# Access Compliance Report

## Public Rights-of-Way

Intersection ID: 25441	Main Street: PROVIDENCE PLANTATION LN	Cross Street: PROVIDENCE SPRING LN	Location: E
ADA ID: FB1EC1B34388	Ramp Type: Perp	Initial Pass/Fail: Fail	Overall Compliance: No
Severity Score: 25			
Codes/Mitigation Info/Possible Solution		Field Measurements/Component Compliance

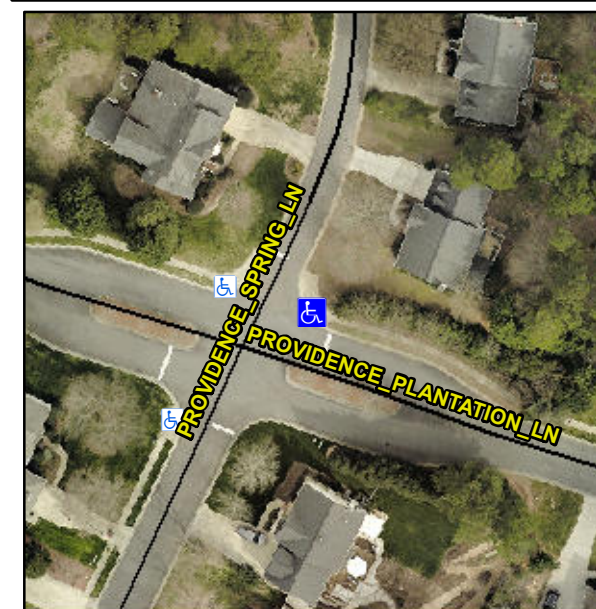
**Not Found, R304.5.3**

Compliance	Description	Data	Compliance	Description	Data
N/A	Ramp Length (in)	48.0	Yes	Ramp Slope (%)	5.1
Yes	Ramp Width (in)	48.0	No	Ramp XSlope (%)	8.1
N/A	Flare Type LT	N/A	N/A	Flare Type RT	N/A
N/A	Flare Slope LT (%)	N/A	N/A	Flare Slope RT (%)	N/A
N/A	Flare Traversable LT?	N/A	N/A	Flare Traversable RT?	N/A
N/A	Landing Length (in)	N/A	N/A	DWS Provided?	N/A
N/A	Landing Width (in)	N/A	N/A	DWS Contrast?	N/A
N/A	Landing Slope (%)	N/A	N/A	DWS Length (in)	N/A
N/A	Landing X Slope (%)	N/A	N/A	DWS Full Width?	N/A
N/A	Landing Curb? (Y/N)	N/A	N/A	DWS Offset (in)	N/A
N/A	Shared Landing?	N/A			
N/A	Gutter Ponding?	N/A	N/A	Gutter Slope (%)	N/A
N/A	Gutter Lip Ht (in)	N/A	N/A	Gutter X Slope (%)	N/A
N/A	Painted X Walk1?	No	N/A	Painted X Walk2?	N/A
	X Walk 1 Direction	To NW		X Walk 2 Direction	N/A
N/A	X Walk 1 Width (in)	N/A	N/A	X Walk 2 Width (in)	N/A
	X Walk 1 Slope (%)	3.6		X Walk 2 Slope (%)	N/A
	X Walk 1 X Slope (%)	4.0		X Walk 2 X Slope (%)	N/A

**Remove & Replace Entire Ramp.**
